ENGINEERING CHANGE REQUEST (ECR)

CUSTOMER DRAWING NO. 972122

DRAWING TITLE BSC Expansion Bellows

REVISION: FROM E TO F

TITLE END FITTING			
SIZE A	CAGE CODE 07649	DWG. NO. Mod 47288-100A	REV
SCALE 1/1	SHEET 1 OF 1

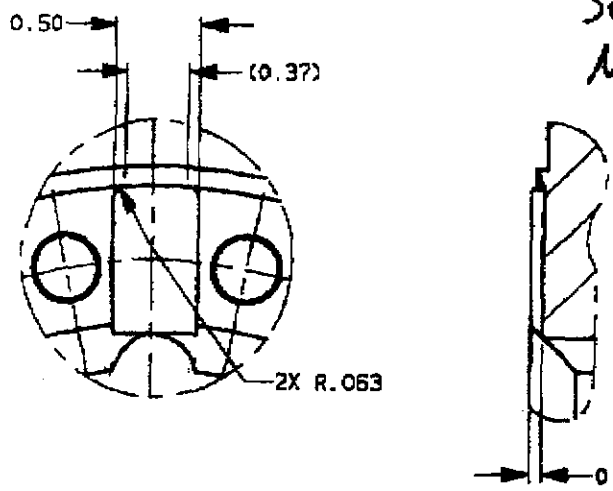
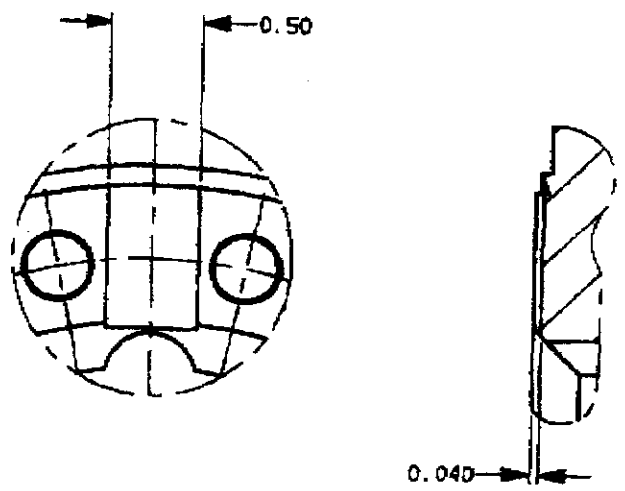
- Change vent slot to reflect actual fab (see attached) ^{OPTIONAL}
- Change Flange tube weldment I.D. & O.D. on Item 3
 I.D. 13.62 now 13.56 (ITEM 3), O.D. 14.02 max now
 13.91 Min Item 3
- Add D.D. Dimension on Dwg 16.500 (3 place)

VENT SLOT = .37" X .063"
PD

OPTION 1

VENT SLOT = .50" X .040"
PD

OPTION 2
